# Technical Service Bulletin

## SB-10056332-3844

SUBJECT:			No: <b>TSB-14-54-010</b>
<b>UPDATED HEADLAMP RELAY CIRCUIT – SERVICE MANUAL REVISION</b>			DATE: <b>July, 2014</b>
			MODEL: <b>See below</b>
CIRCULATE TO:	<input type="checkbox"/> GENERAL MANAGER	<input type="checkbox"/> PARTS MANAGER	<input checked="" type="checkbox"/> TECHNICIAN
<input checked="" type="checkbox"/> SERVICE ADVISOR	<input checked="" type="checkbox"/> SERVICE MANAGER	<input type="checkbox"/> WARRANTY PROCESSOR	<input type="checkbox"/> SALES MANAGER

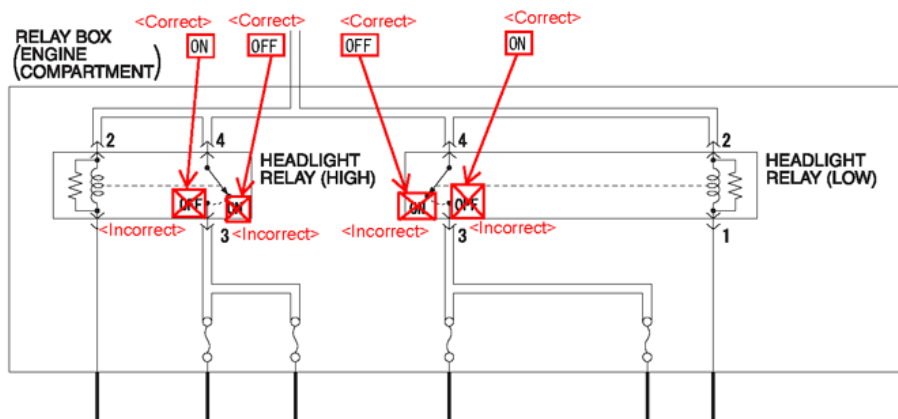
This TSB corrects references in the headlamp relay circuit.

Please make the indicated changes to the service manuals listed above.
